# City of North Liberty

## Request for Proposals (RFP) – ADDENDUM 1

Centennial Park Event Complex Phase 1

Audiovisual Systems

A6 FIRST FLOOR REFLECTED CEILING PLAN  
1/8" = 1'-0" 0" 12"

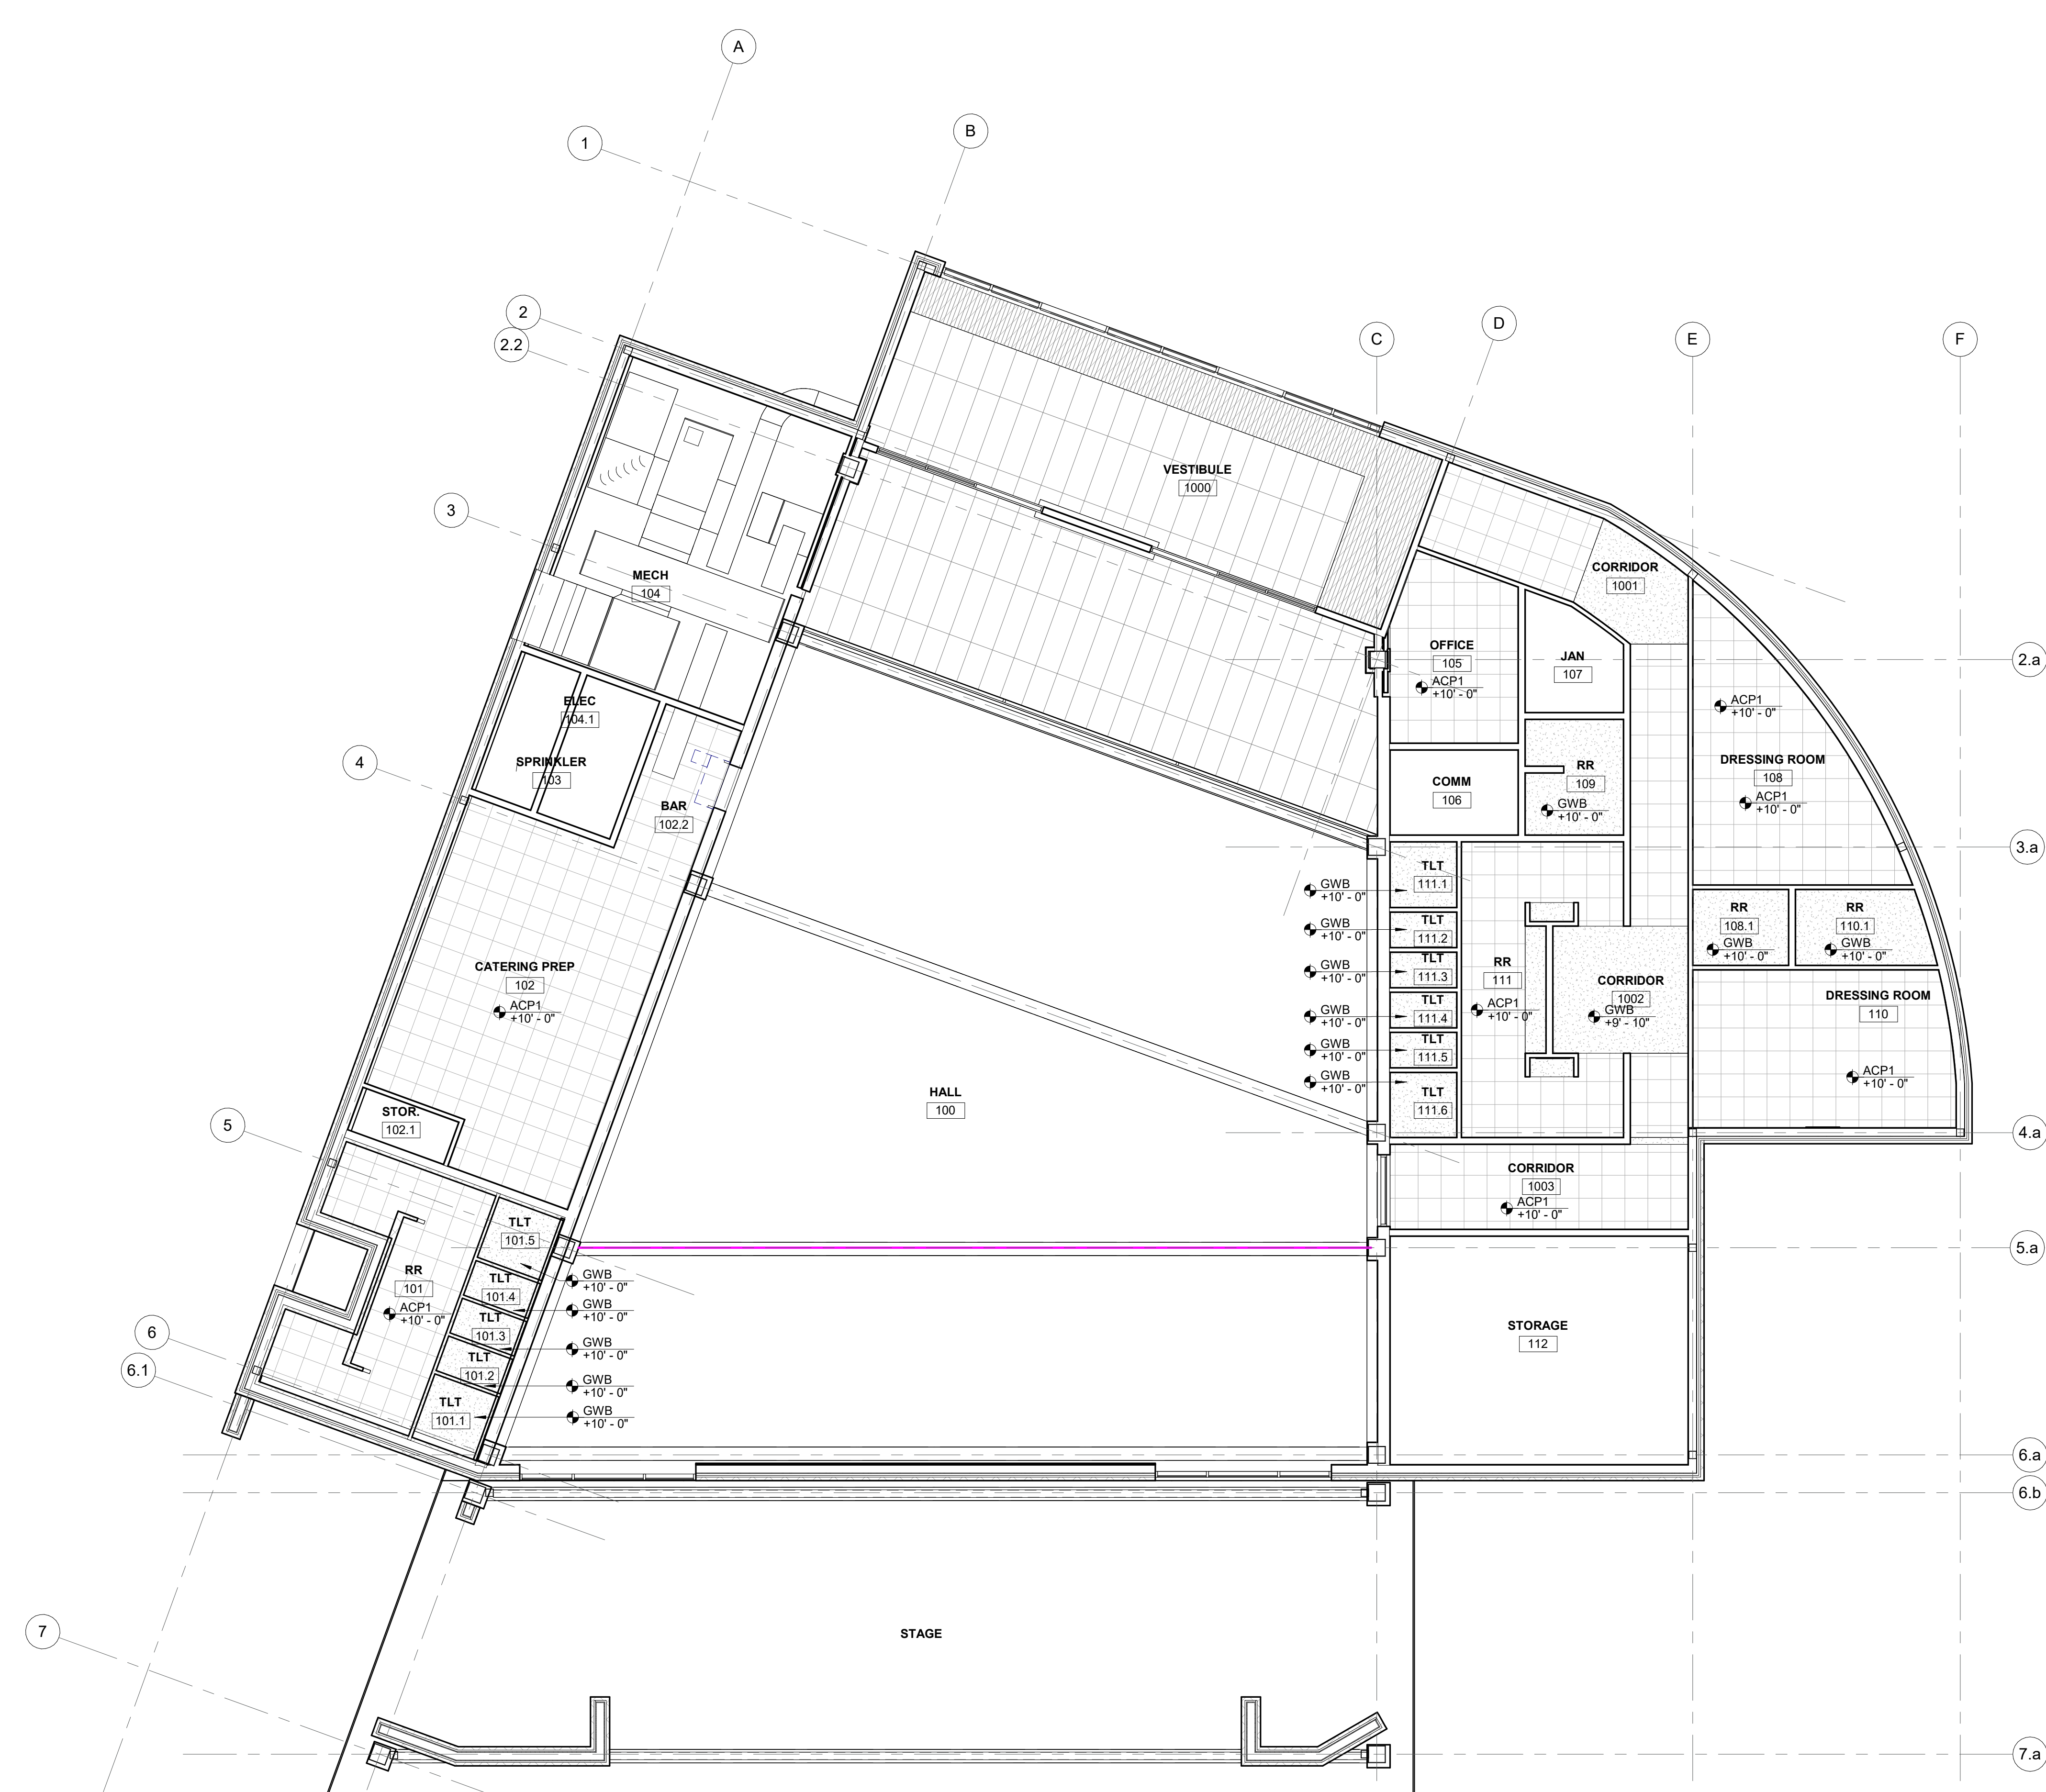
4. Attachments
  1. A131 First Floor Reflected Ceiling Plan dated 8/12/23.
